**From:** Paul Smith <paulsmithplanning@outlook.com>  
**Sent:** 03 August 2021 10:05  
**To:** Gosset, David <david.gosset@herefordshire.gov.uk>  
**Cc:** Tim Fycun [REDACTED]  
**Subject:** RE: Drawing - Land Adjacent Amarant House, Harewood End.

**From:** Paul Smith <[paulsmithplanning@outlook.com](mailto:paulsmithplanning@outlook.com)>  
**Sent:** 02 August 2021 15:33  
**To:** Gosset, David <[david.gosset@herefordshire.gov.uk](mailto:david.gosset@herefordshire.gov.uk)>  
**Cc:** Tim Fycun [REDACTED]  
**Subject:** FW: Drawing - Land Adjacent Amarant House, Harewood End.

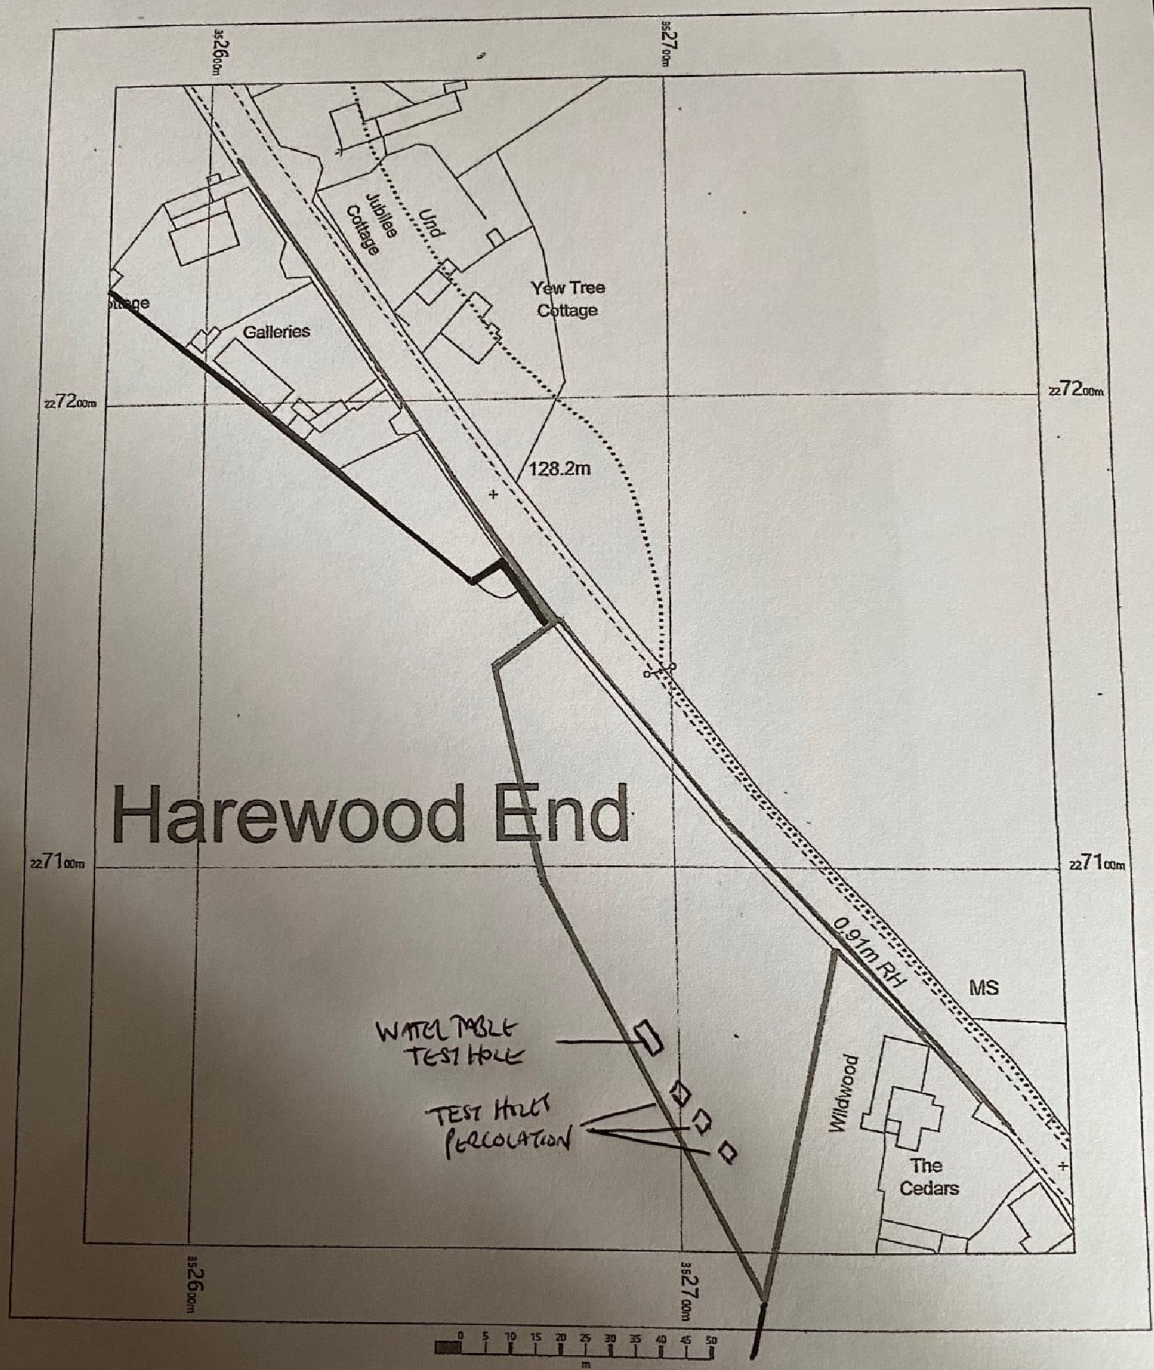
I have conferred with my drainage consultant who has marked the positions of the test holes as requested (see below).

My consultant also confirms that the proposed drainage field is designed to fully conform with BS6297.

Approx. Locations marked as requested  
All the best  
Tim
